In the Drawings:

FIG.2

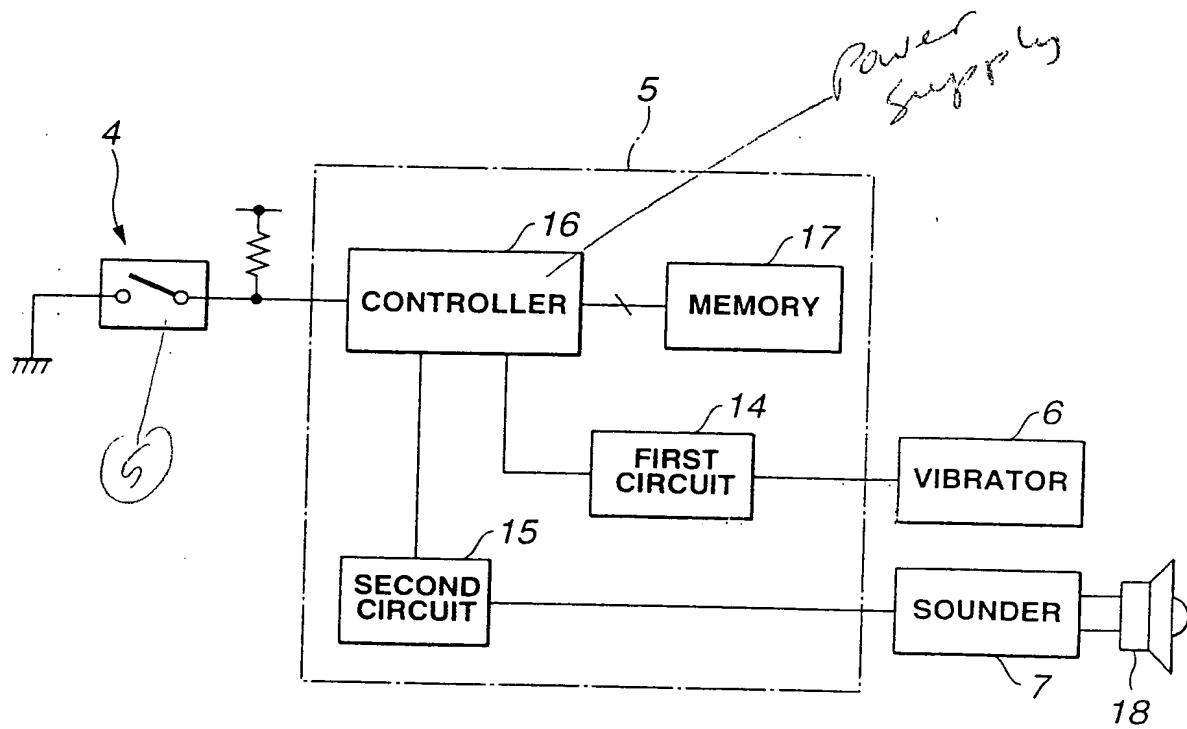
Approval is respectfully requested for exchanging legends between elements 14 and 15 in Figure 2 to correspond to the specification at page 5, lines 13-20. Formal drawings including this revision are submitted concurrently herewith.
